## Response to Reviewers

Review of “Impact of correcting sub-daily climate model biases for hydrological studies”, Faghih al.

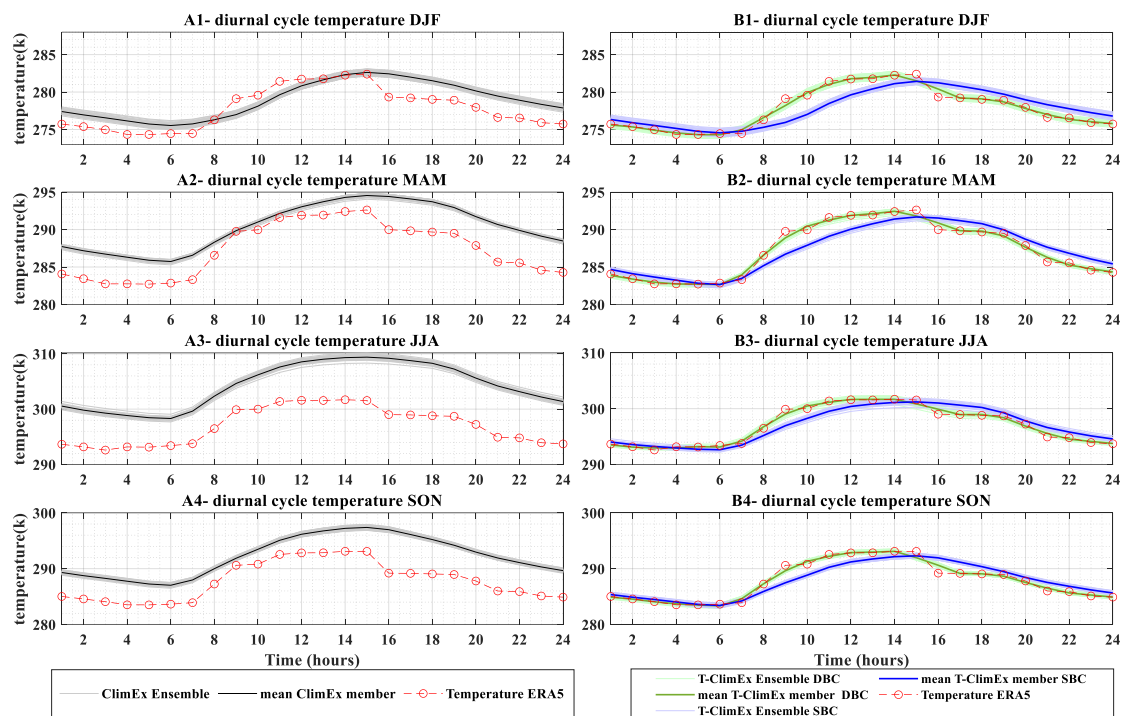
- Figures. The figures and their captions need improvement. Labels 'a', 'b', etc. are missing; often unclear whether 1 particular year is considered or an average over 24 years; x-axis time in hours has no reference to what is 0, whether this is local time or UTC, mismatches with the text that discusses AM and PM, and over a year and indication of months would still be more logical; for sample watersheds it is sometimes specified which ones they are and sometimes it simply isn't making reproduction impossible; legends often refer to multiple panels, thus placing them outside a panel makes more sense; some figures present 'envelopes' without defining what exactly these envelopes mean in the caption.

Additional details were added to Figure 3 and 4 including captions. The locations of legends were changed and labels (A, B) were added to the subplots. Times are all local. With 24h corresponding to midnight. Clarifications have been added in the text and AM/PM time have all been modified to a 1-24 hour format.

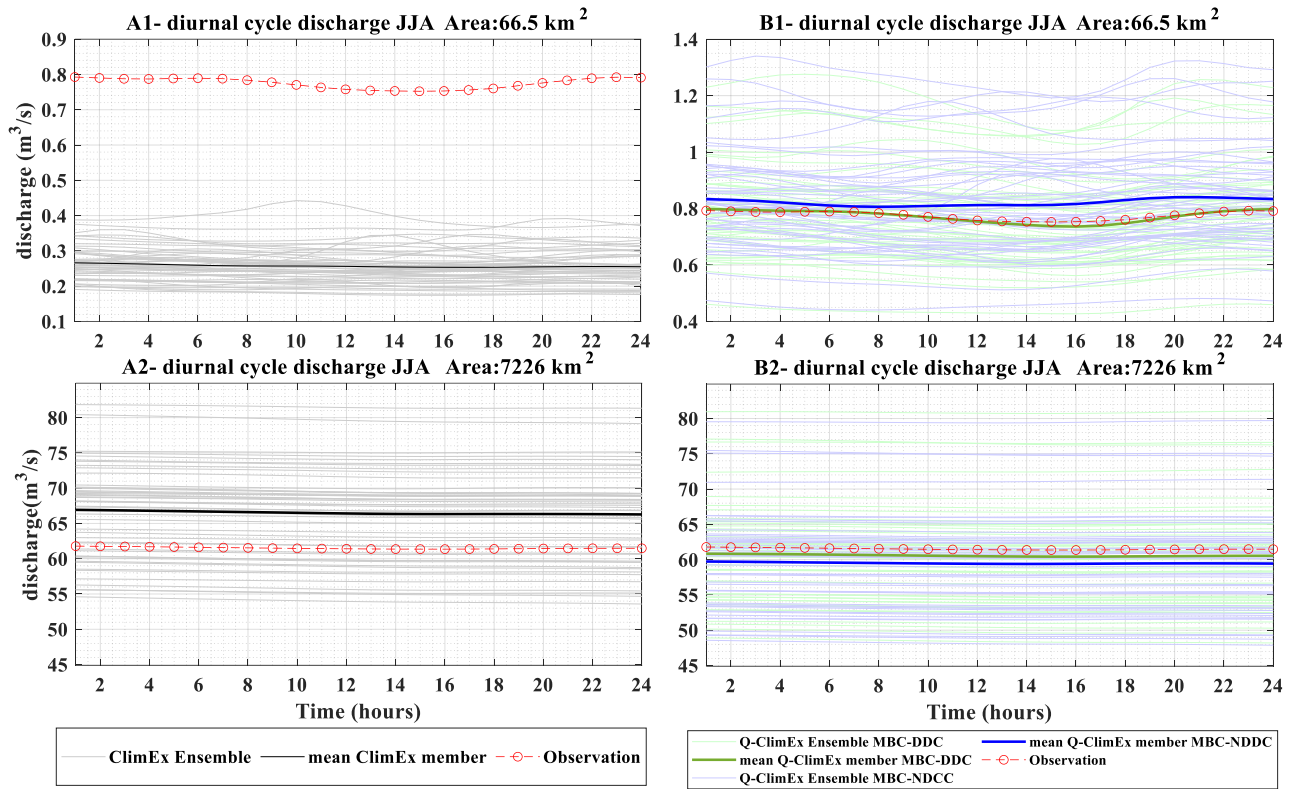
Line 371: A discussion is provided on the diurnal cycle due to evapotranspiration in the smaller catchments, with this being better represented after bias correction. I agree that this is may well be detectable in flow records for small catchments. However, when looking at figure 3 it would appear that there is a diurnal cycle in the temperature data. Indeed, the temperature in JJA has such a cycle but a clear positive bias, which one would expect would increase evapotranspiration further. Yet in Figure 10 there is no diurnal cycle at all in the unbiased simulations. This does seem somewhat incongruent. It may be good to explore this a little further. Overall Figure 10 can be improved in clarity also as it is not very clear.

The location of the legend was changed in Figure 10 and the caption was modified.

Your comments led us to understand that we were not clear enough in our description of Figure 10. There are diurnal cycles for both temperature and evapotranspiration on all catchments, independent of size. This suggest that there is also a surface runoff diurnal cycle which results from the above factors on all catchments, irrespective of size. However, this surface runoff cycle can only be seen on catchment which have a reaction time smaller than approximately 12 hours so that the catchment outlet can register differences between day and night processes. This is what we were trying to show with Figure 10. We have added to the Figure description in the revised version of the manuscript and made changes to the Figure as demanded by Reviewer 1.

**Figure 1 Distribution of watersheds across North Eastern America. Circles and triangles symbols correspond to small, medium and large catchments respectively.**

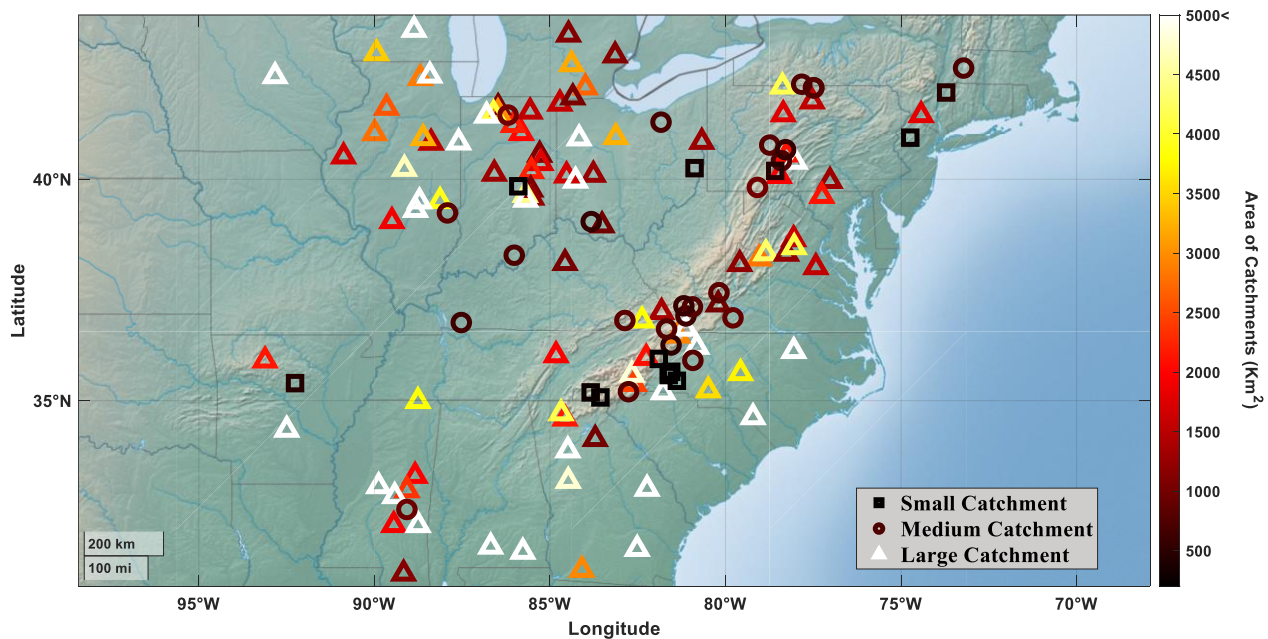
Line 110: The figure presenting the different catchments could be bit more informative. The size of the circle as well as the colour are now used to indicate how the catchments fall in the different categories. One of these dimensions is redundant. As there are some larger catchments, the division across the three scales the paper focuses on is not clear. One could perhaps use a different symbol (square, circle, triangle) for the category and colour for the size would be more informative. It is also clear from the table that the sample of small catchments is in fact quite small. How well are these spread over the different hydro-climatologies, or are they concentrated in the more mountainous Appalachians (it is not so clear in the figure)?

The figure was modified accordingly. In the new figure the square, circles, and triangles represent small, medium and large watersheds respectively. As can be seen from the distribution of the squares, the small catchments are distributed across the study area and are not limited to the Appalachians. We would have preferred having a larger sample of small catchments, but it is a limitation of the MOPEX database.

Figure 5 Hydrograph annual cycles for four selected catchments. Catchments A and B are classified as large and medium size respectively. Catchments C and D are classified as small. 0 represents January first at 0h00, and 8760 is December 31st at 24h00.

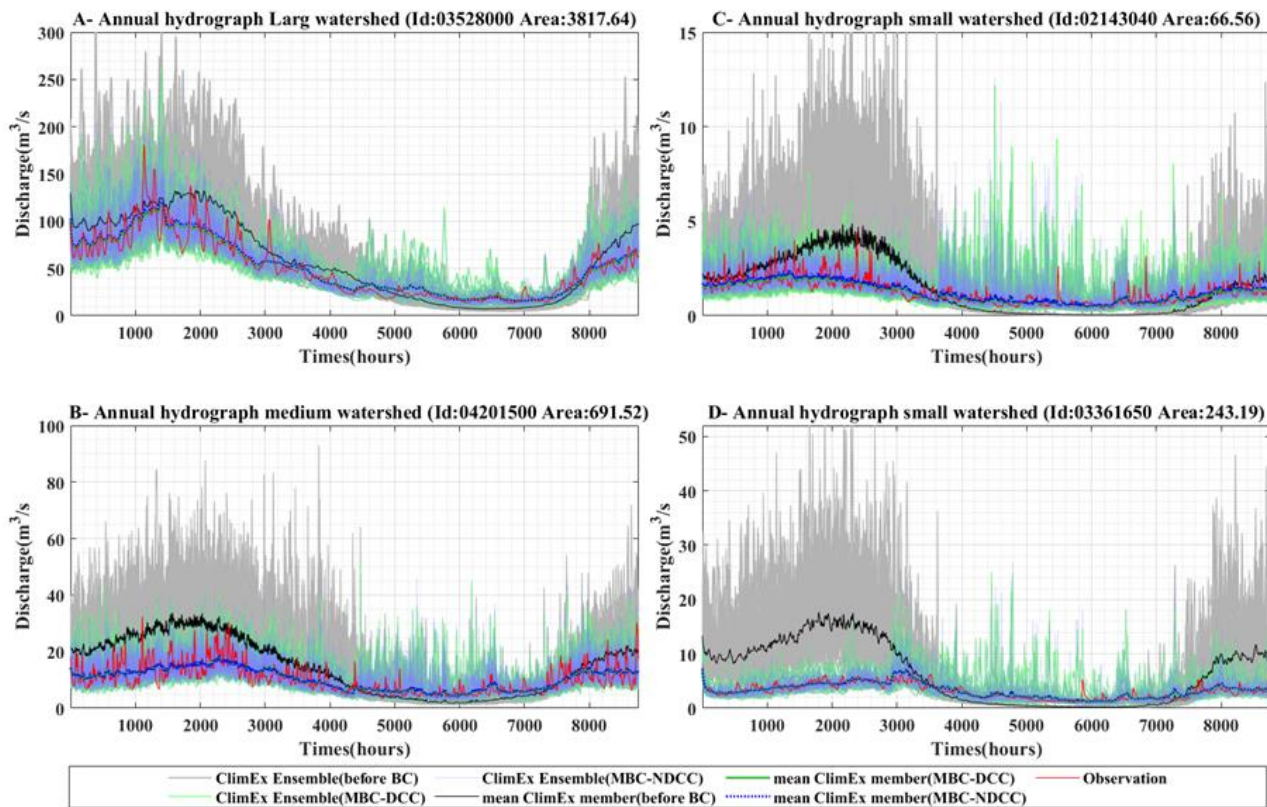
Line 262: Figure 5 is not very easy to read. It is mentioned that the light blue curves overlap – but it is very difficult to identify what is what in the figure. This could well be improved. It is also not fully clear of the average biases, as the lower part of the different lines is obscured. Given the information the authors want to convey, would it perhaps be more appropriate to present in the form of a flow duration curve? This may well not show the full variability, but it does provide information on the average annual spread. I would suggest the authors try in any case to make the figure a little clearer.

The transparency of the blue line has been changed in the revised version. It definitely allows for a better comparison between both curves.

**Figure 6 Hydrographs of two sampled catchments for the month of July (744 hours=31 days \* 24 hours) (small and large size surface area)**

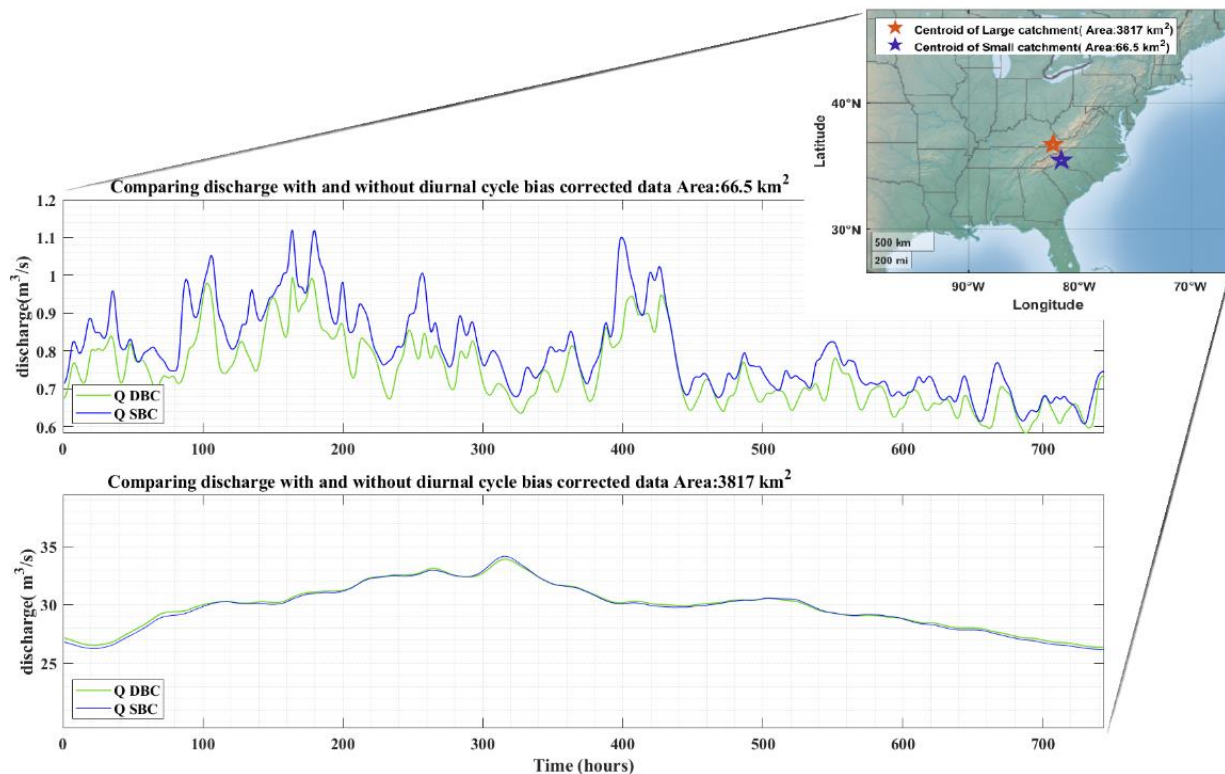
Line 271-274: I think it is important here to be explicit on the question if the climatic characteristics and the dominant processes that shape the regime (pluvial – nival) of the two catchments compared are indeed similar, thus supporting the claim that the diurnal variability being more apparent in the smaller catchment is indeed attributable to catchment size.

We made sure that both catchments were geographically close and displayed similar climate characteristics. We are therefore confident that the main differences come from the catchment size. This is a good point however, and we have added precisions in the revised manuscript and have modified Figure 6 to show the localization of both catchments (see new Figure 6 below).

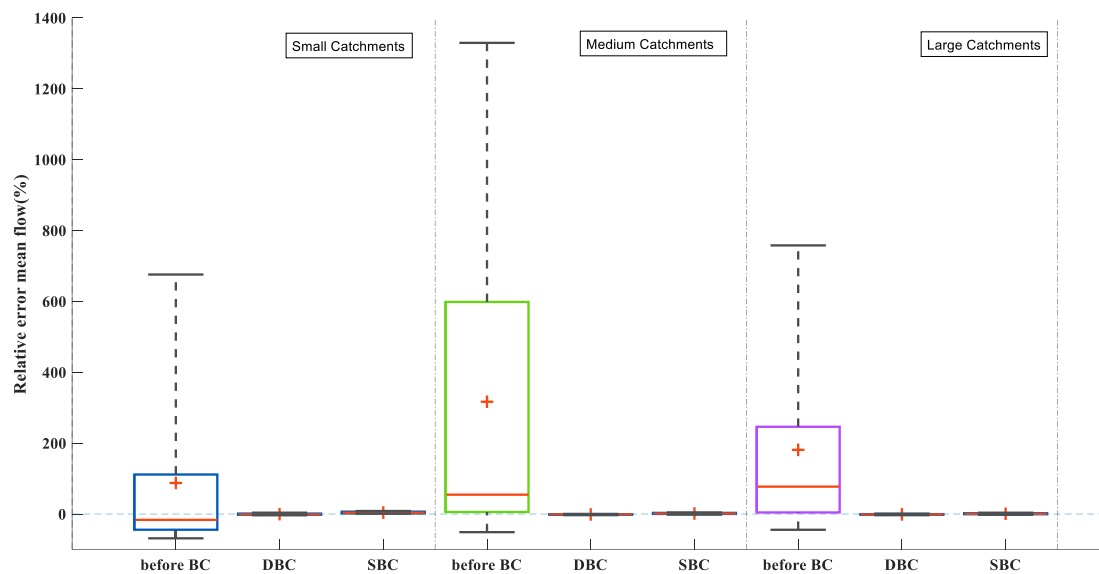
Line 297: Figure 7 shows the relative biases of the small, medium and larger catchments after bias correction. The unbiased model results are not shown. Perhaps this was an obvious choice, but it may be valuable to include these, at least in Fig 7, to understand the relative improvement for each of these scales. Also, in Figures 7,8 & 9 it is clear that the diurnal bias correction always results in a more negative bias than the standard bias correction. This is commented on in the text, but the authors do not provide possible explanation. Is the bias corrected precipitation consistently lower; the temperature and consequent evaporation consistently higher? I would assume this is the case, as if it simply a diurnal

redistribution of moisture, then this may not be so consistently seen in the larger catchments. Please comment.

We have not included the boxplots of uncorrected simulations because the biases are up to two order of magnitude larger than for the corrected ones, as can be seen in the Figure below. While these conclusively demonstrate the need for bias correction, it is simply not possible to outline the difference between both bias correction methods if the uncorrected boxplots are shown on the same Figure. We have instead added a sentence in the revised version explaining why the uncorrected model results are not shown.
